Determination 2013/062

Regarding the issuing of a code compliance certificate for building work affecting other property at 2C Hastie Avenue, Mangere, Auckland

Figure 1: site plan (not to scale)

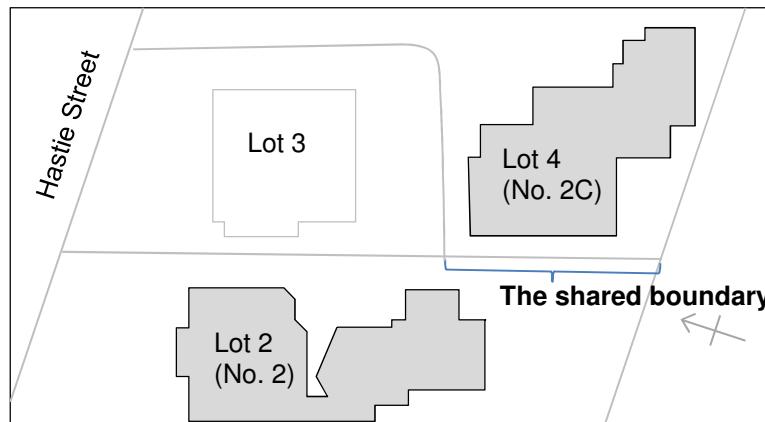
- 2.3 The height difference between the two properties either side of the shared boundary is approximately 2.3m at the northern end; this reduces slightly towards the south where it then drops away suddenly to be almost equal at the south boundary.

- 2.4 To form the building platform for Lot 4, considerable site excavation was carried out which left a vertical bank along almost the entire length of the shared boundary and part of the north boundary of Lot 4. The applicants’ agent described the site as having an exposed near vertical bank along almost the entire length of the shared boundary which, due to a lack of support, slumped over time.

- 2.5 The vertical bank remaining on the site of Lot 2 was later modified by battering and stabilizing it to avoid more slumping. The battered length extends approximately 18 metres before it falls away steeply to the rear boundary, and about 12 metres of the battered length is almost 2 metres high.

- 2.6 No engineered retaining wall has been installed, but a 1.8m high fence was constructed at or on the shared boundary at the bottom of the excavation for Lot 4. The fence is approximately 3m from the house on Lot 4 and is in line with an existing fence between Lots 2 and 3.
